Commonwealth Edison
 One First National Plaza, Chicago, Illinois
 Address Reply to: Post Office Box 767
 Chicago, Illinois 60690

Subject: Proposed Change to Appendix A of DPR-19
 (Dresden Unit 2) - AEC Dkt 50-237

Pursuant to Section 50.59 of 10 CFR 50 and Paragraph 3.B of the Facility License DPR-19, Commonwealth Edison Company hereby submits a proposed change to Appendix A of DPR-19 (Dresden Unit 2). The purpose of this change is to modify the fuel densification specification as related to the gap conductance model.

FIGURE 3.5.1 MAXIMUM ALLOWABLE PLANAR LEGR

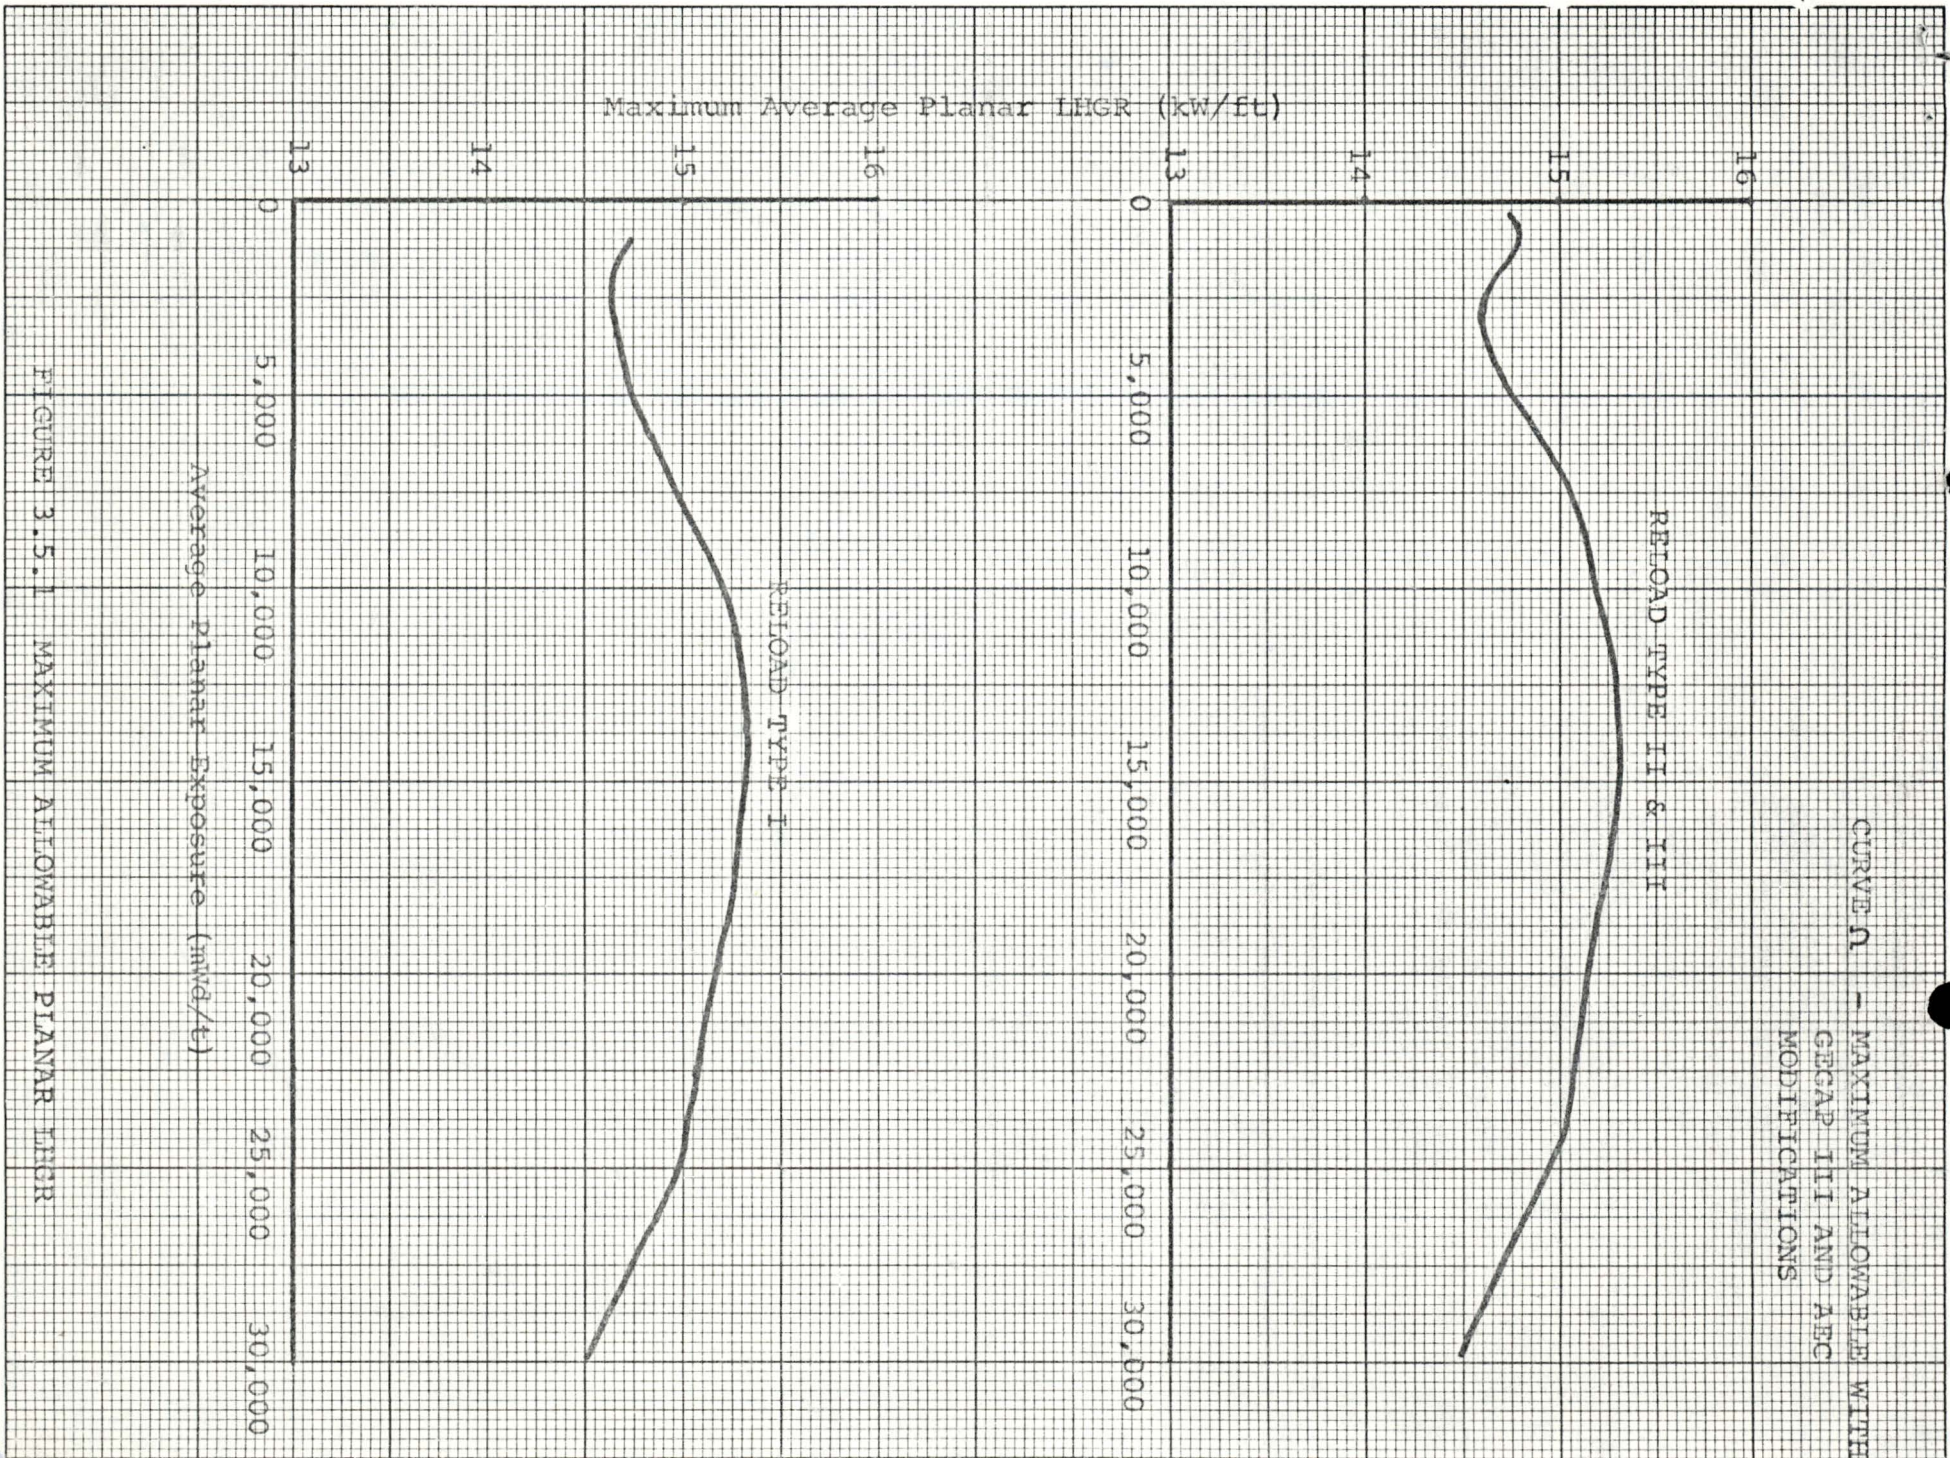
CURVE A - MAXIMUM ALLOWABLE WITH
GEGAP III AND AEGC
MODIFICATIONS

The maximum average planar LHGR shown in Figure 3.5.1 is the same as that shown on the curve labeled " Ω " (omega) on Figures 3-H and 4-H in the General Electric letter of J. A. Hinds to V. A. Moore, "Plant Evaluations with GEGAP-III," dated December 12, 1973, based on calculations employing the models described in the General Electric reports NEDM-10735 as modified by the General Electric report NEDO-20181.
